<b>Well Name:</b> GB JACKSON TR6	<b>Well Location:</b> T17S / R30E / SEC 27 / TR 6 / NWNE /	<b>County or Parish/State:</b> EDDY / NM
<b>Well Number:</b> 3	<b>Type of Well:</b> INJECTION - ENHANCED RECOVERY	<b>Allottee or Tribe Name:</b>
<b>Lease Number:</b> NMLC028992B	<b>Unit or CA Name:</b> GRAYBURG JACKSON	<b>Unit or CA Number:</b> NMNM70955X
<b>US Well Number:</b> 3001504356	<b>Well Status:</b> Water Injection Well	<b>Operator:</b> SAGUARO PETROLEUM LLC

**Notice of Intent**

**Sundry ID:** 2758402

### PLUG AND ABANDONMENT CONDITIONS OF APPROVAL

**PROPOSED**

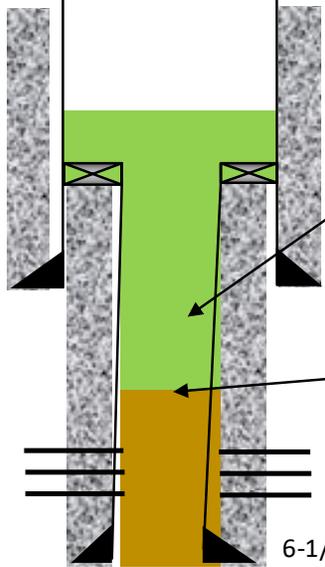
Plug 3:  
 $450' \times 0.0903 \text{ ft}^3/\text{ft} + 120' \times 0.0818 \text{ ft}^3/\text{ft} + 4' \times 0.2273 \text{ ft}^3/\text{ft} + 566' \times 0.1370 \text{ ft}^3/\text{ft} = 129 \text{ ft}^3$

Plug 2: Perf. & squeeze 100' w/ 10% excess (1270'-1170')  
 $100' \times 0.0818 \text{ ft}^3/\text{ft} \times 1.1 = 9 \text{ ft}^3$   
Base of Salt: 1220'

Plug 1: 138' (3014'-2876') w/ 30% excess:  
 $(88' \times 0.1370 \text{ ft}^3/\text{ft}) + (50' \times 0.2273 \text{ ft}^3/\text{ft}) \times 1.3 = 31 \text{ ft}^3$

Set CIBP 50' - 100' above perfs  
 Fill @ 3014'

- 1) Set CIBP at 3098'. Leak test CIBP. Spot cement from 3098' to 2846'. WOC and Tag. 32 sxs CI C. (7" shoe, Top of Liner, top of CIBP.
- 2) Perf and squeeze from 1495' to 1158'. WOC and Tag. (In 58 sxs/Out 21 sxs) Class C. (Yates, B. Salt)
- 3) Perf and squeeze from 616' to surface. (In 125 sxs/ Out 62 sxs) Verify at surface. (T. Salt, liner shoe, surface casing shoe)
- 7) ND BOP and cut off wellhead 5' below surface. RDMO PU, transport trucks, and pump truck.
- 8) Set P&A marker.

- No more than 3000 feet between cement plugs in cased hole.
- Wait on Cement and Tag Top of Cement Requirement:
  1. Shoe, Top of Salt, Base of Salt, DV tool, Perforate and Squeeze, Open Perforation.
  2. Formation plug is optional if a solid base is established and confirmed.
